Novak Electronics Inc.
17032 Armstrong Ave, Irvine, CA 92614
Web: www.teamnovak.com
March 2011

SERVICE BULLETIN - TRANS CAP MODULE

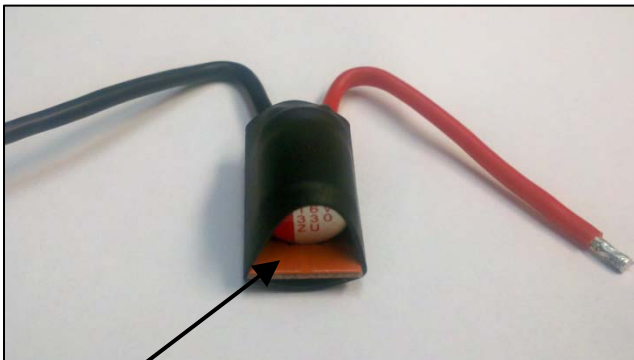
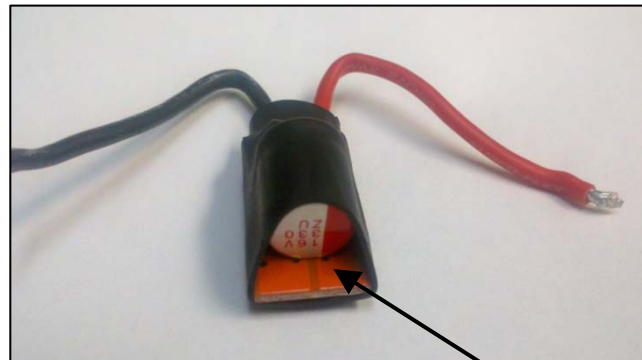
It has come to our attention that there have been an unknown number of **Novak #5678 Lightweight Power Trans-Cap Modules** built incorrectly. The capacitor was installed onto the trans-board backwards. This will lead to problematic operation of the speed control (ESC), and eventual capacitor failure.

INCORRECT: Red stripe on capacitor is soldered to red wire.

Please check your ESC's Trans Cap Module before any further usage. If you find you have an incorrectly installed item, please contact Novak immediately so the problem can be rectified. Do not switch the 16awg wires on your Trans Cap Module.

CORRECT: Red stripe on capacitor is soldered to BLACK wire.
